Planning and Environment Court

Application in Pending Proceedings – Contempt of Court

David Manteit V Brisbane City Council & Orrs 2916/24

128 ASHRIDGE RD DARRA APPROVAL QUESTIONS

12) Filling and/or Excavation

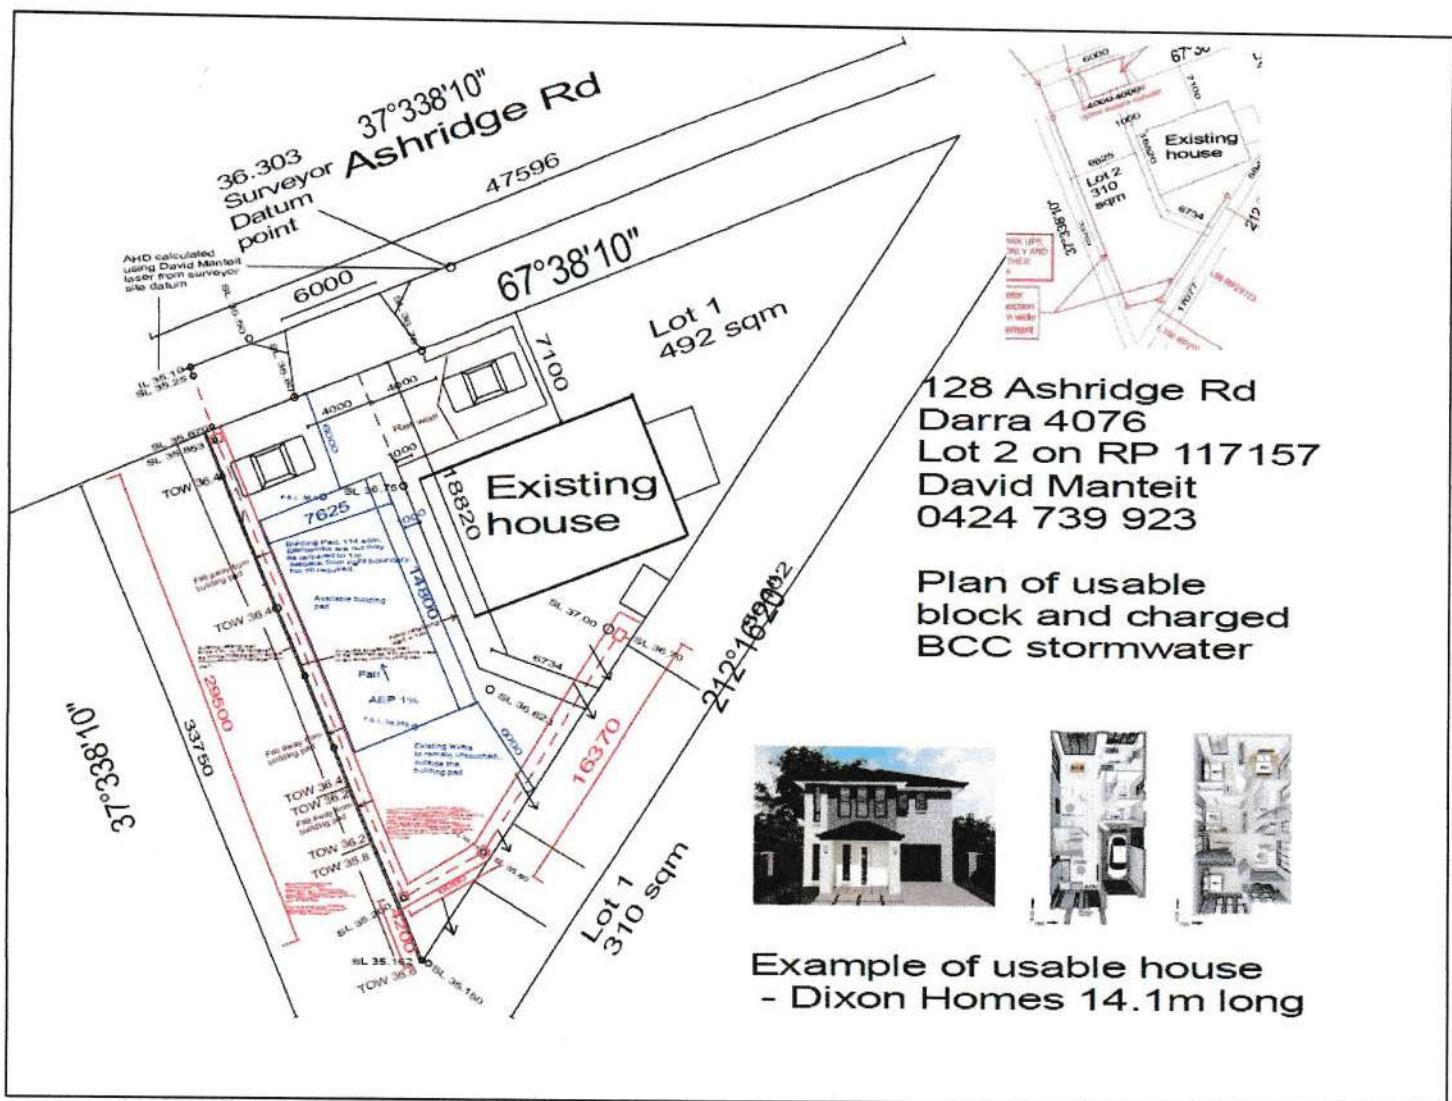
- 1. Please advise if you accept my building pad dimensions in the attached plans as a suitable building pad.**
- 2. Please advise what associated earthworks would be required to “enable” when it is painfully obvious the AHD 35.166 at front boundary commands the block and a legal point of discharge is already enabled and all existing and future levels are above 35.66 on the right side and pad level is 36.0 which is some 334 mm above the AHD 35.166 at the front boundary.**
- 3. Please demonstrate why the site must be filled to enable lawful point of discharge for the Ashridge Rd lots.**

Stormwater side elevations

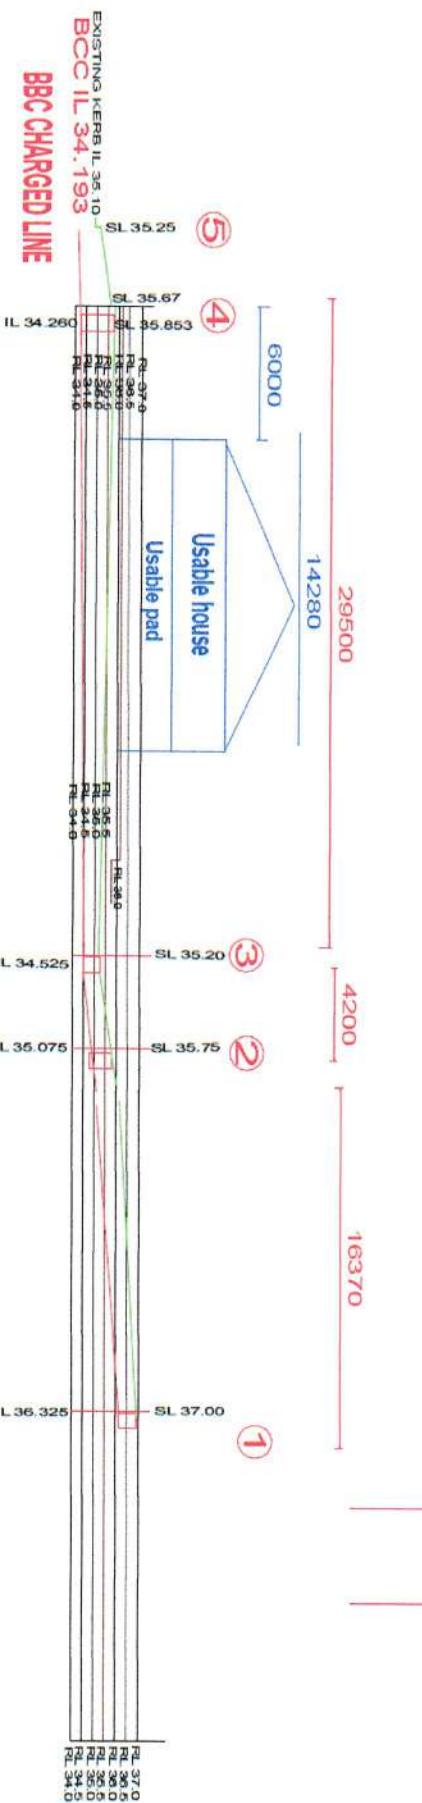
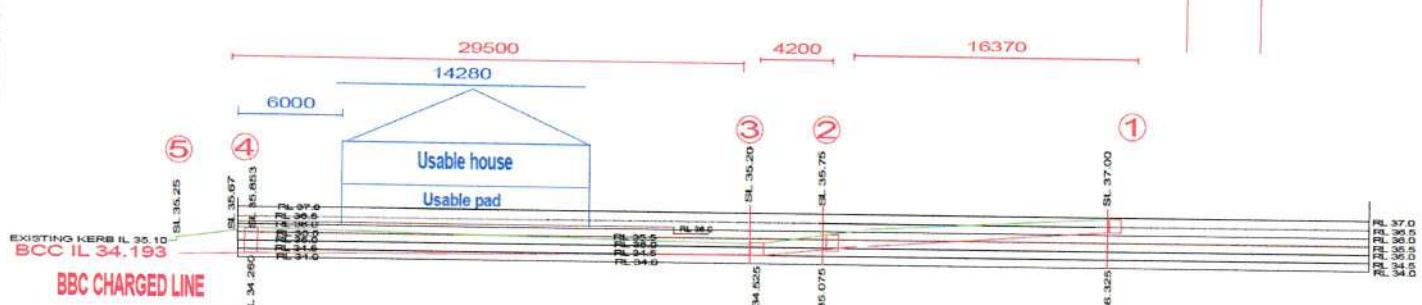
BCC CHARGED LINE for "alleged upslope" properties

I have attached plan view and crosssection to demonstrate that the BCC red line shown of the BCC approved plan is charged.

5. Please provide BCC surface and invert levels of BCC proposed stormwater red line plan for supposed upslope rear lots used in the assessment of the red line. This has been asked many times to BCC including Joel Wake verbally and letters in writing recently. Council refuses to supply same. Dishonest. It is your design, not mine. You take ownership of the red line.

Side elevations of block
BCC charged stormwater line
Ashridge Rd lots legal point of
discharge.

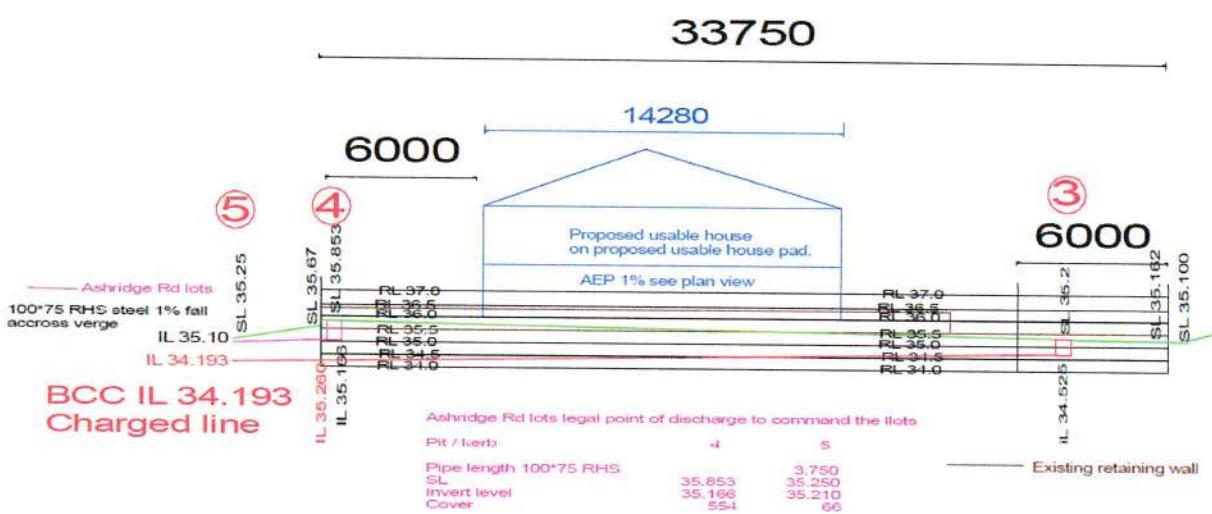
Scenario 1 - 450 cover and .5% fall as per BSD 8111 requirements
Calculations done against red line shown on BCC approved plan.

The invert level at kerb as per the BCC approved plan is 35.100. This was arrived at by the applicant using his laser level in conjunction with the surveyor kerb site datum of 36.303.nThis took me all of 60 seconds, as both marks are only some 10 metres away from each other and both on the kerb.

Approved BCC plan showing fall at the rear boundary is to the subject property.

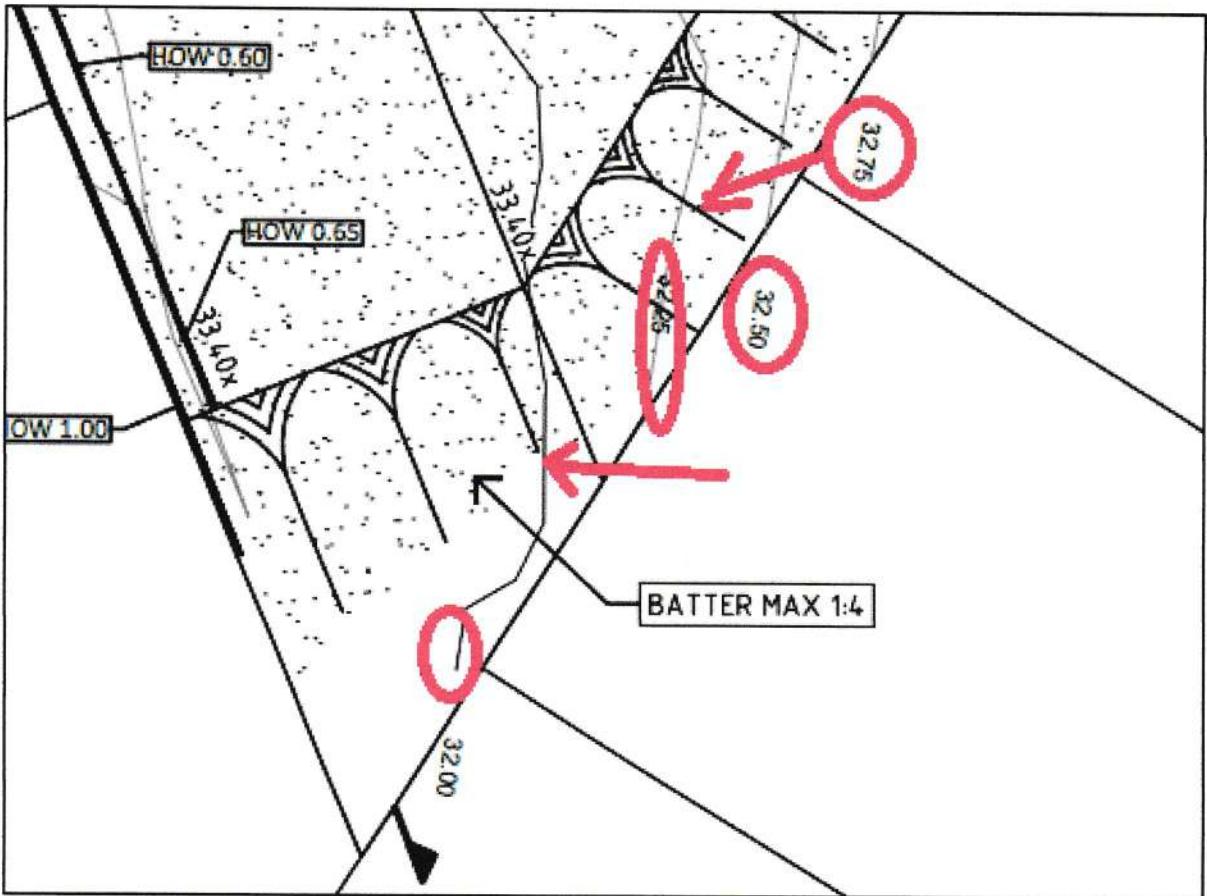
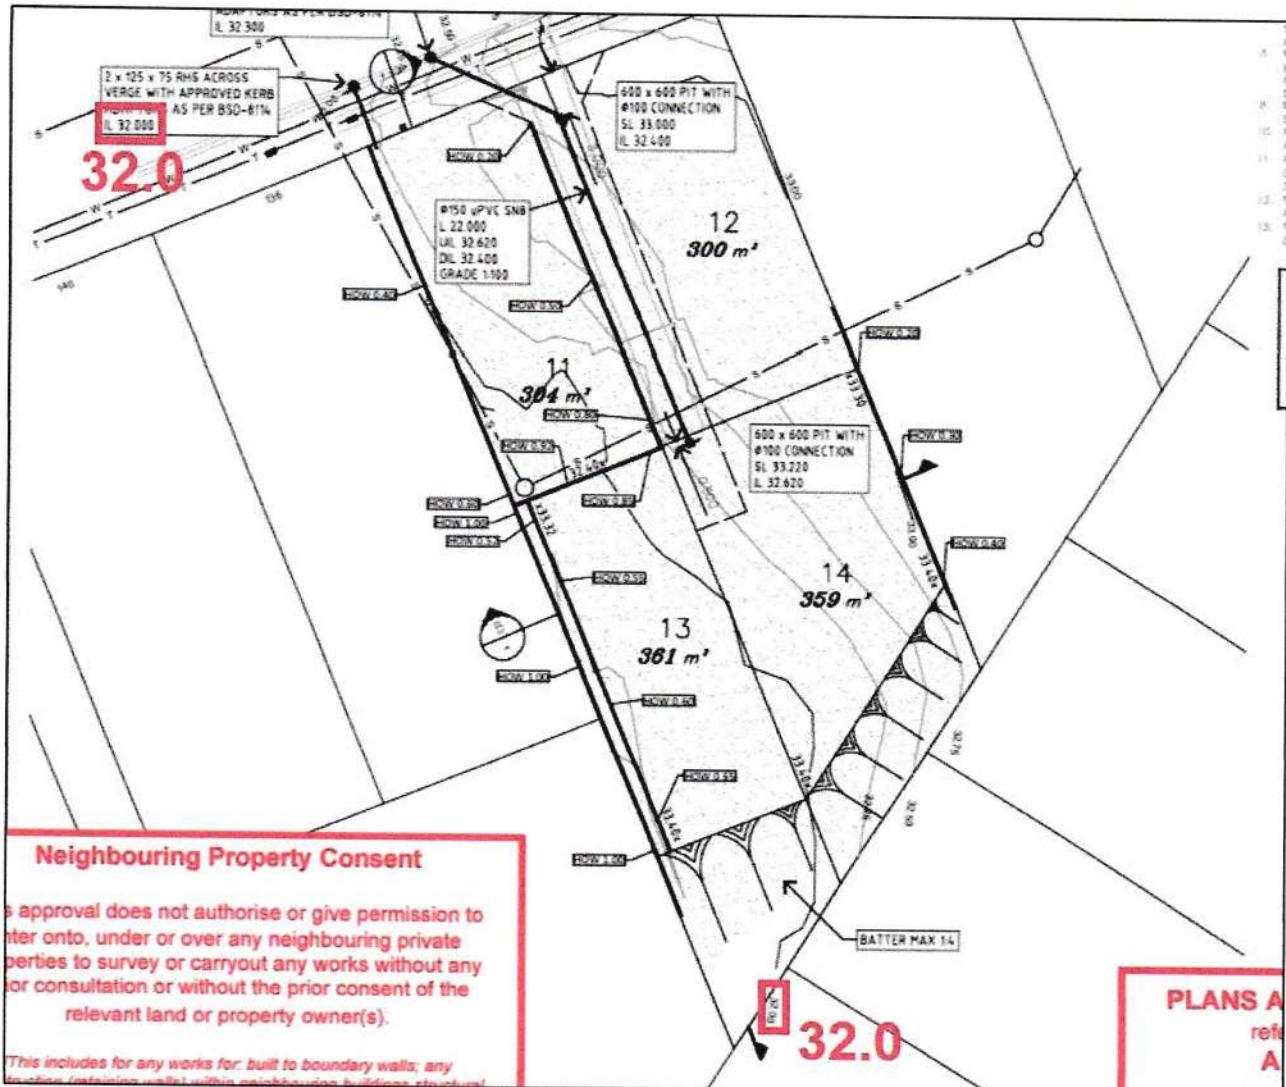
7. Please advise why 134 Ashridge Rd (17 metres away from the subject development) approval did not require a 225mm pipe to rear properties if the fall at rear boundary is to the 134 Ashridge Rd property whereas the slope at the rear for the subject property 128 Ashridge Rd, is to the rear properties.

The above plan of approval for 134 Ashridge Rd Darra shows zero **Overall fall from rear to front of 32.0 to 32.0.**

8. How was the decision in relation to stormwater made for 134 Ashridge Rd? What tests were applied? In relation to the 134 Ashridge Rd property the BCC decision was not to provide a stormwater legal point of discharge to rear properties.

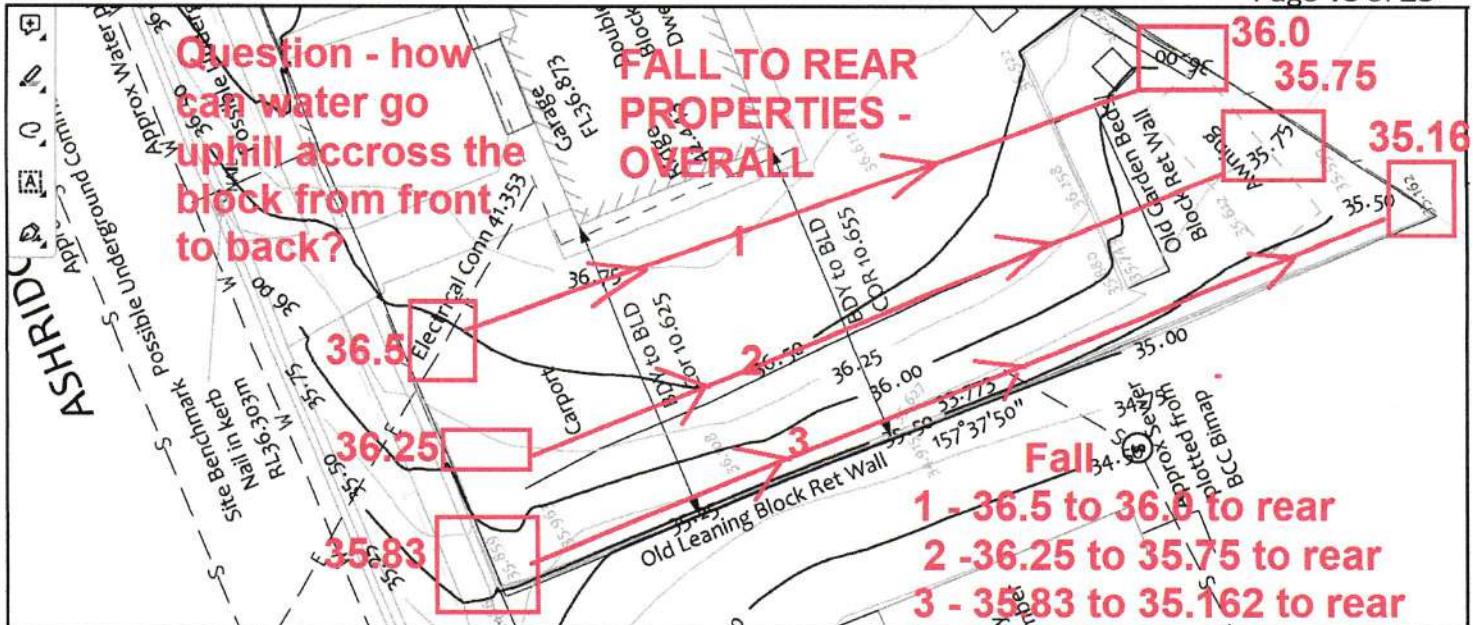
10. Will BCMT be able to inspect a stormwater end of line at the kerb that is .907mm, .984 mm, 12.49 mm below the kerb?

11. Will BCMT sign off on the inspection of the kerb at the construction phaset that is a sham design?

Possible crosssection of council
225 mm pipe mid air Roman aquaduct
stage one. To be confirmed by BCC.

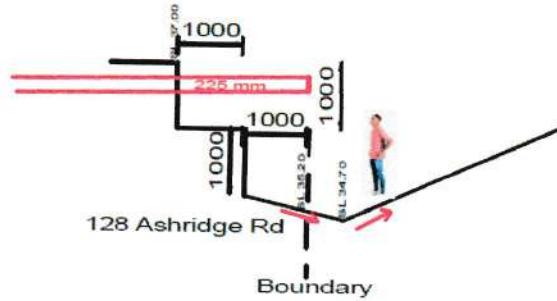
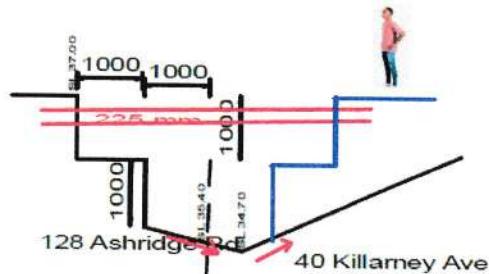
Possible crosssection of council
225 mm pipe mid air Roman aquaduct
complete. To be confirmed by BCC.

22. Can BCC RPEQ please provide their crosssections and mathematical calculations used to determine legal point of discharge ? This includes crosssection at the stub location of Lots 98 and 99 to demonstrate they are/are not proposing a Roman Aquaduct system as above.

I have provide my calculations. Please provide your calculations by 5pm Thursday 10/10/24.
